Planning Rationale Addendum Report

## Laurelpark Estates – Third Submission

### Draft Plan of Subdivision and Zoning By-law Amendment

Prepared for Laurelpark Inc.  
by IBI Group  
May 8, 2020

**Figure 1:** Draft Plan of Subdivision

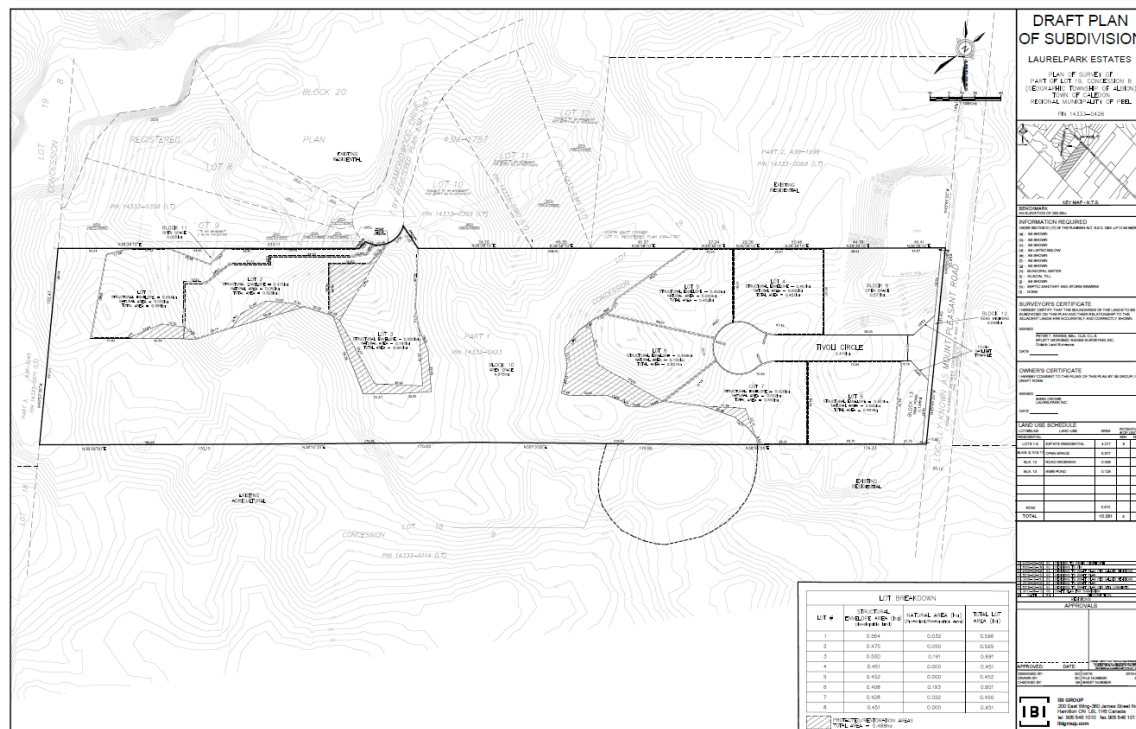
The following minor changes were applied to the previous version of the draft plan of subdivision to address staff comments and concerns:

- Consent approved for lands on the adjacent parcel (Lot 9, Diamondwood) and lands have been added to the Draft Plan of Subdivision accordingly;
- Minor adjustment to the eastern boundary of Lot 4 and 5 to regularize Lot 4 for future homeowners;

- Minor adjustment to the southern boundary of Lot 2 to regularize the lot for future homeowners;
- Lot 1 and 2 now each have direct frontage onto Diamondwood Drive;

- With respect to Lots 1 and 2, a shared driveway with access easements is proposed rather than a private condominium road in accordance with Town staff recommendations per our meeting;

- A more detailed chart was created that includes the Total Lot Area, Structural Envelope Area, and Natural Area;
- Condominium road was removed as a block on the Land Use Schedule;

- Detail A on the Draft Plan was removed as a result of the revised stormwater management block configuration; and,
- The PIN number has been updated.

### Figure 2: Proposed Shared Driveway

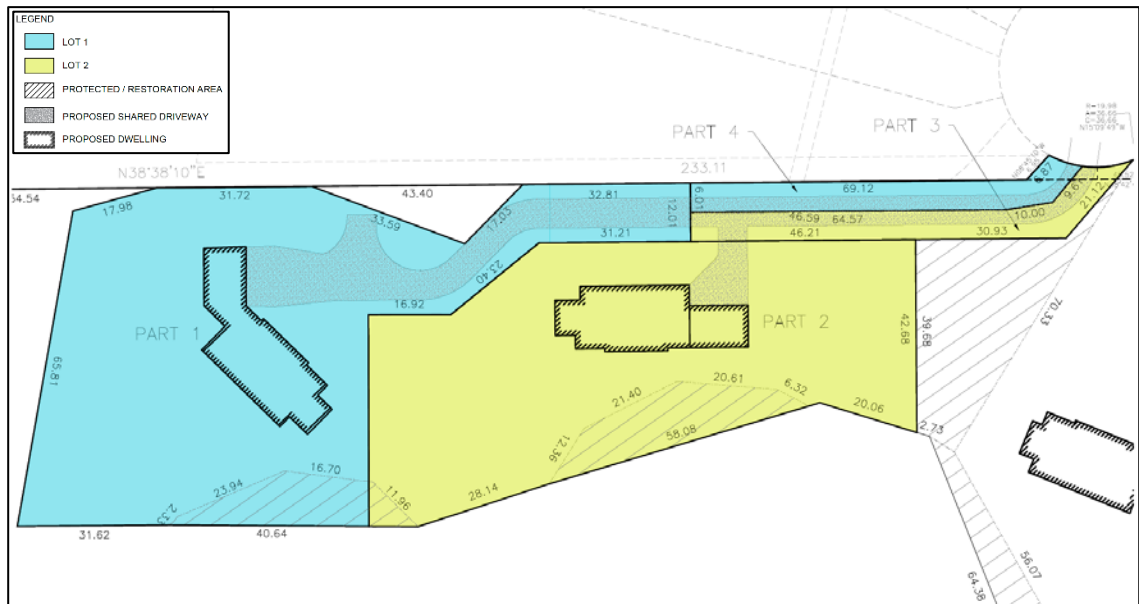
*Please note that staff have continued concerns with the irregularity of the following proposed lots:*

- a) Please revise the eastern boundary of the structure envelope on Lot 4 to regularize the lot area for future homeowners (i.e. creating natural area triangles at the northern and southern end of Block 9). Please note that the revised structure envelope area for Lot 4 should not be less 0.3 ha, as per Section 7.1.9.3 of the Town's Official Plan.*
- b) The proposed lotting and structure envelopes for Lots 1 and 2 are highly irregular and require a condominium plan to gain access to Diamondwood Drive. Staff encourage the applicant to consider merging Lots 1 and 2 into a single lot which would improve the lotting pattern and structure envelope mapping and provide frontage and direct driveway access to Diamondwood Drive.*

- a) An adjustment to the eastern lot line of Lot 4 has been applied to regularize the lot for future homeowners, simultaneously maintaining a minimum structure envelope of 0.45 ha.

- b) The lot configurations of Lot 1 and 2 are largely formed as result of environmental constraints. Further, Policy 7.1.7.3 of the Town of Caledon Official Plan prevents Block 11 from being included as part of Lot 1. Nonetheless, even as a separate block on the plan of subdivision, Block 11 will essentially function as part of Lot 1, and will be transferred to the future homeowners of Lot 1 given neither the Town nor TRCA have an interest in acquiring the block for open space purposes. The block will be maintained in its natural state through the use of a conservation easement and zoning restrictions. Moreover, the southern boundary of Lot 2 has been straightened in attempt to regularize the lot. Further, a shared driveway approach is proposed that will facilitate access to the future dwellings on Lots 1 and 2, as demonstrated in **Figure 2** below. As a result, lot frontage has been created onto Diamondwood Drive for both Lots 1 and 2, removing the need for a Plan of Condominium that was previously required to permit a private road for two lots. We acknowledge that an access easement will be required to facilitate the proposed shared driveway approach.

**Figure 3:** Technical Map 8 Excerpt, Prepared by Calder Engineering

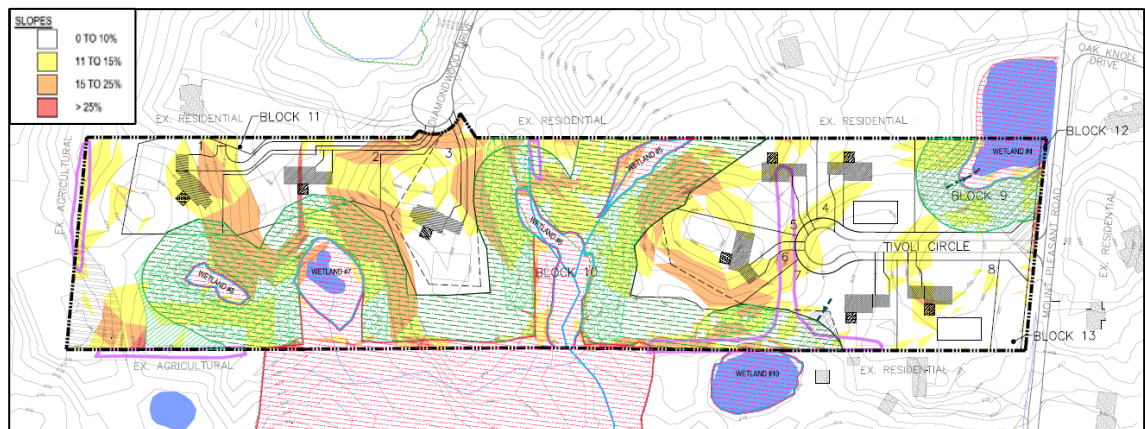
*Please note that in accordance with Section 7.1.9.11 of the Official Plan, structure envelopes shall generally be restricted to slopes of 10 percent or less. Structure envelopes may include areas with an 11-15% slope and occasionally greater than a 15% slope, in order to permit the advantageous siting of a house designed for steep slopes. Staff remain concerned that Lots 1 and 2 does not achieve this policy direction and encourage the applicant to consider merging Lots 1 and 2 into one lot to minimize landform disturbance.*

**Planning Response:** Policy 7.1.9.11 of the Official Plan states, “Structure Envelopes will generally be restricted to areas with slopes of 10 percent or less. However, Structure Envelopes may include areas with an 11-15 percent slope, and occasionally greater than a 15 percent slope, in order to permit the advantageous siting of a house designed for steep slopes. Houses shall be sited on middle to lower slopes where possible and designed in harmony with the natural topography so as to minimize visual impact. In all cases the Structural Envelope must include a suitable well drained area with slopes of 10 percent or less for a sewage disposal system” (emphasis added).

The above-noted policy uses the words “generally”, “may include”, and “occasionally”, which are suggestive rather than prescriptive, binding terminology. A large majority of the proposed structure envelopes are restricted to areas with slopes of 10 percent or less. Technical Map 8 prepared by Calder Engineering determines the respective Structure Envelopes with slopes ranging from 0-10%, 11-15%, and greater than 15%, demonstrating general consistency with the above-note policy, as shown in **Figure 3** below. Evidently, the structure envelopes are generally restricted to areas of slope with 10% or less. Where it is unavoidable, structure envelopes include slope areas of 11-15% and occasionally greater than 15%.

DRAFT PLAN  
OF SUBDIVISION

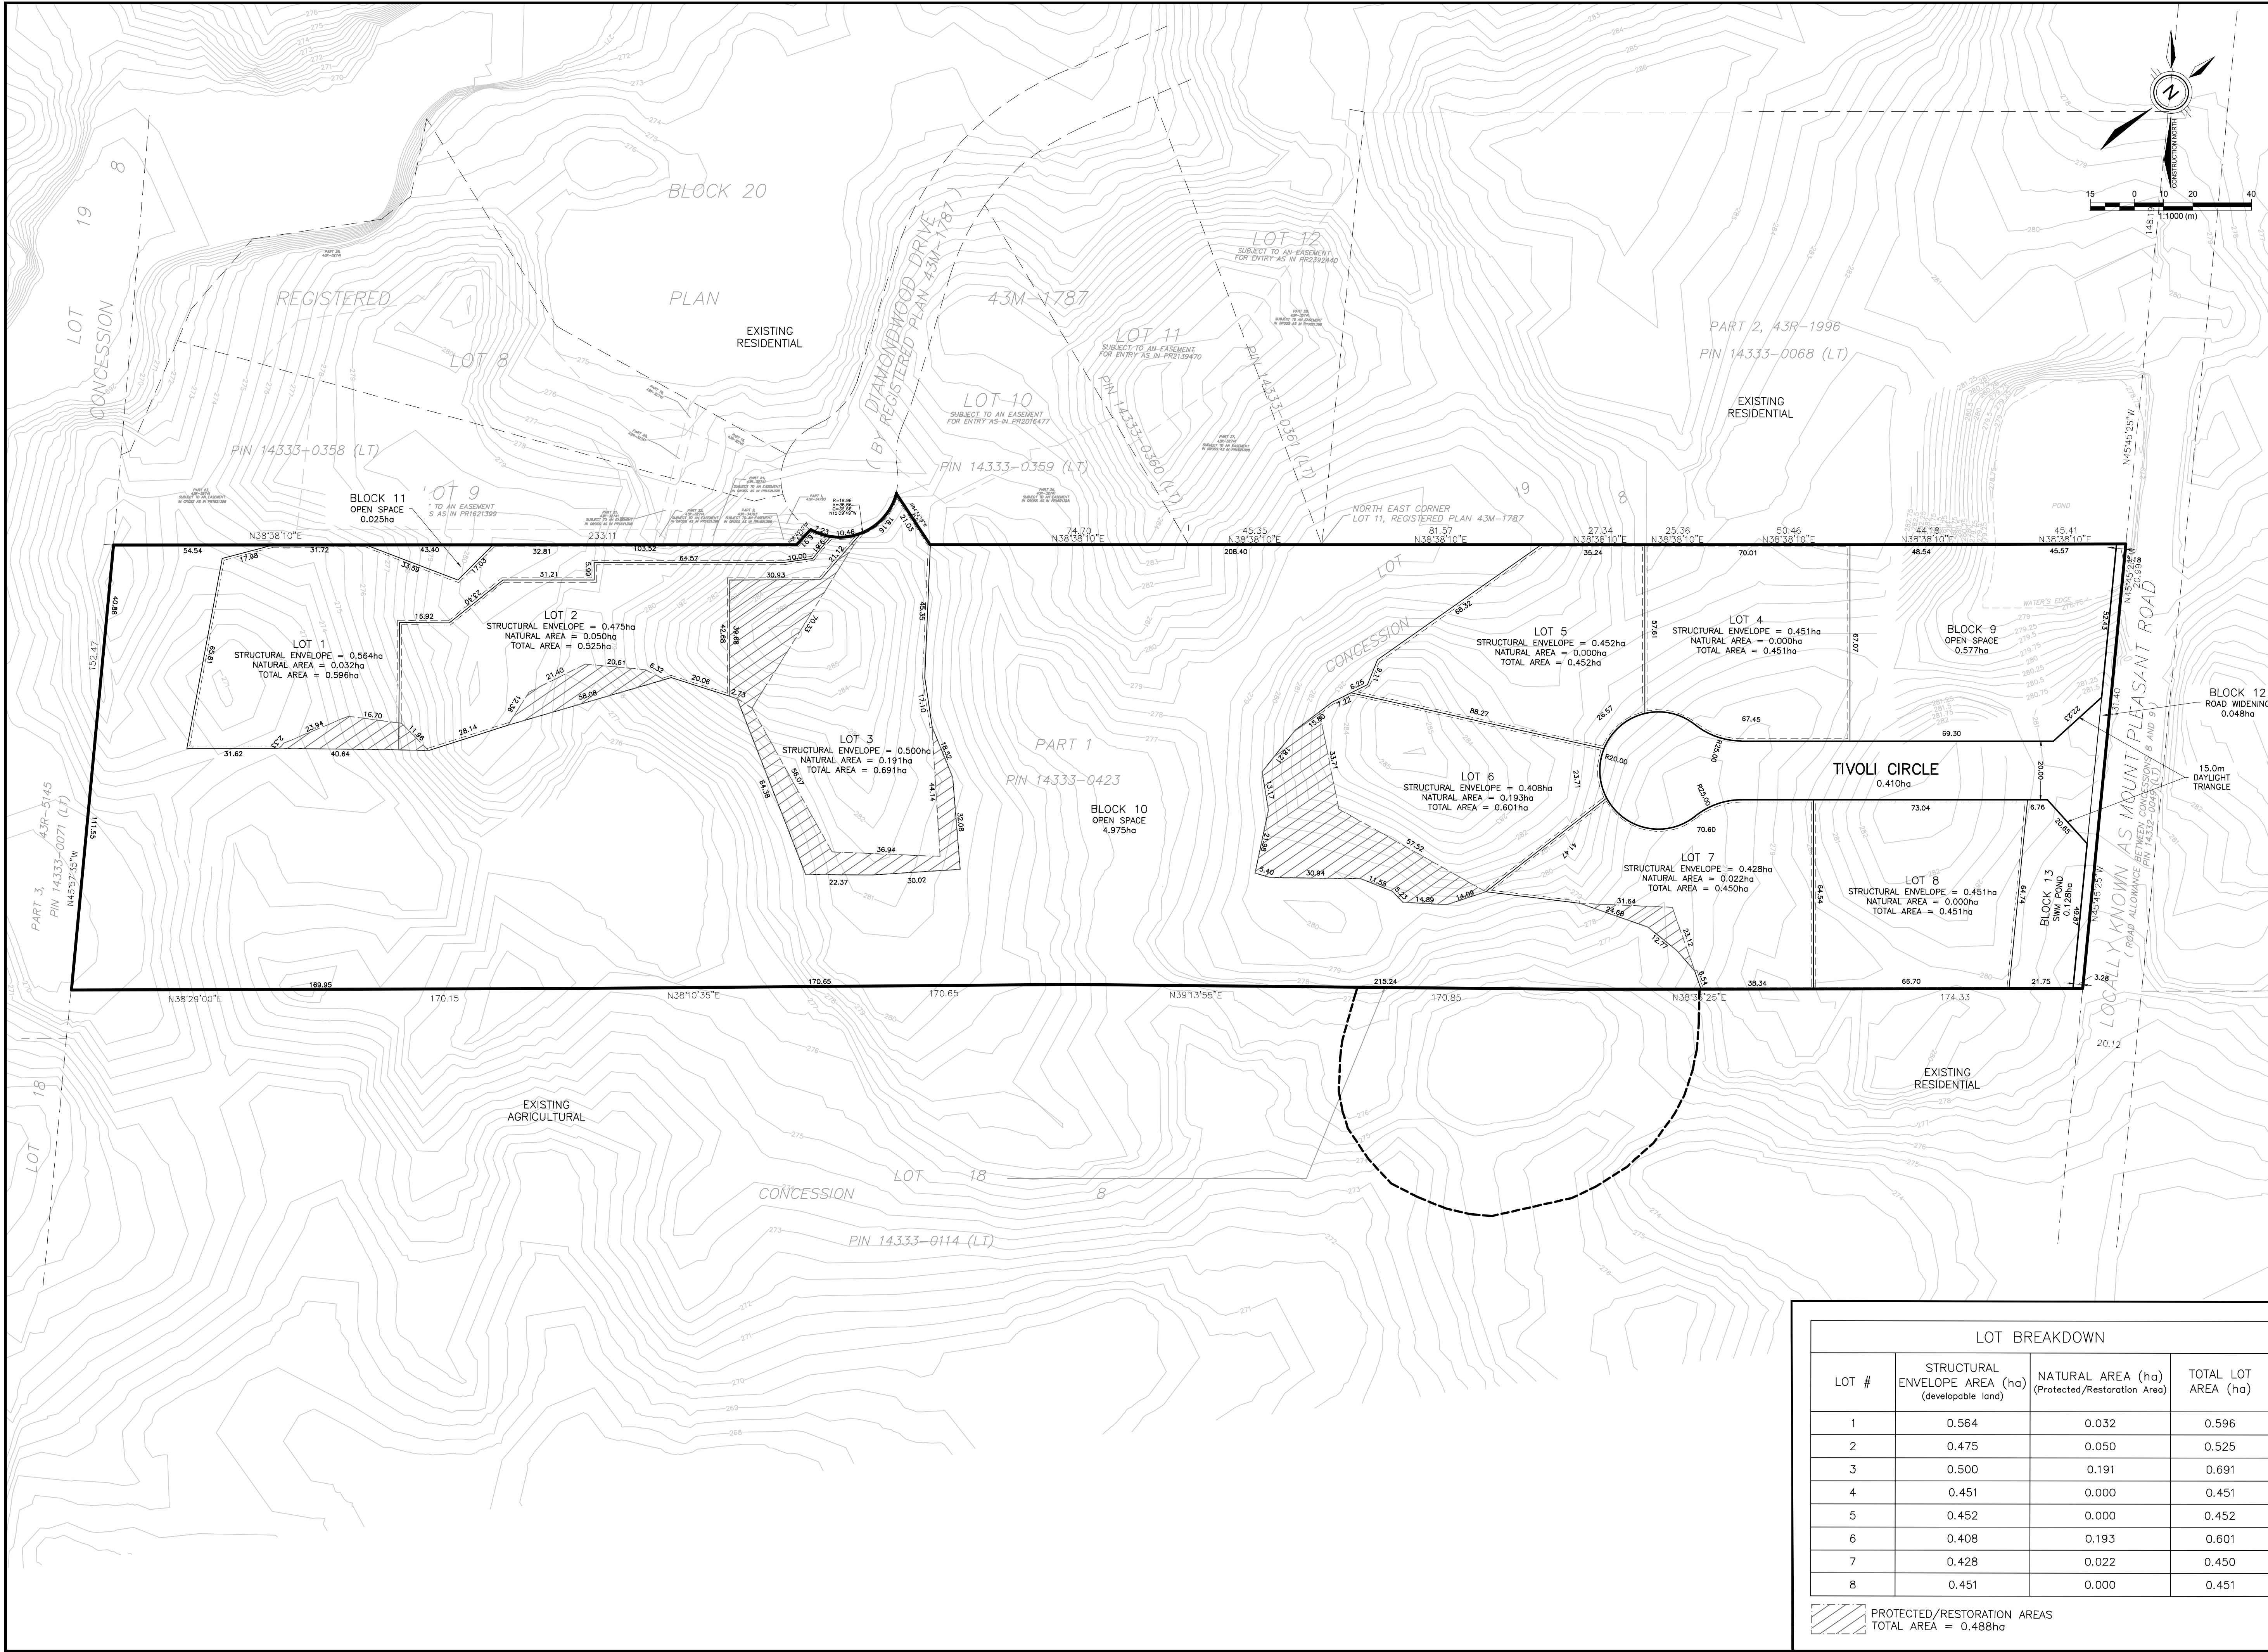
*Please revise Detail A on the Draft Plan to read Block 14 for the 0.3m reserve, as per the Land Use Schedule.*

*Lots 1 and 2 contain EZ1 features (i.e. MVPZ's to Wetlands 7 and 8). As per Policy 7.1.7.4, EZ1 may be included within a lot (outside of a structure envelope) but may not be included in the calculation of net lot area. It appears the lots statistics on the Draft Plan or Environmental Mapping include the EZ1 area in the lot area for Lots 1 and 2; please revise.*

*As per the engineering comments herein, Block 15 may not be suitably sized for a SWM block. This could have implications on the Draft Plan.*

**Planning Response:** Detail A has been removed altogether, as the stormwater management pond block has been increased approximately 0.038 ha, resulting in a revision to the Lot 8 configuration and removing the requirement of a 0.3 metre reserve. Please refer to **Appendix B** for further details.

The Draft Plan of Subdivision and Environmental Mapping accurately depict the lot statistics, which have been further broken down on the revised Draft Plan of Subdivision to include structural envelope area, natural area, and total lot area for clarity purposes. EZ1 features are not included within the calculation of the net lot area. Please refer to **Appendix B** for further details.

**Planning Response:** The area of the SWM block, now referred to as Block 13, has been increased on the Draft Plan of Subdivision by approximately 0.038 ha. Calder Engineering confirmed that the proposed bioretention area is a hybrid between a traditional "bioretention area" and a "dry" pond as the drainage area serviced of 1.81 hectares is larger than maximum recommended drainage area of approximately 0.8 hectares in the Low Impact Development Stormwater Management Planning and Design Guide. The proposed bioretention area has been provided with sufficient storage volume to provide peak flow control without reliance on volumetric storage available in underlying filter media, pea gravel, and clear stone. Please refer to the preliminary engineering and stormwater management report for further details.
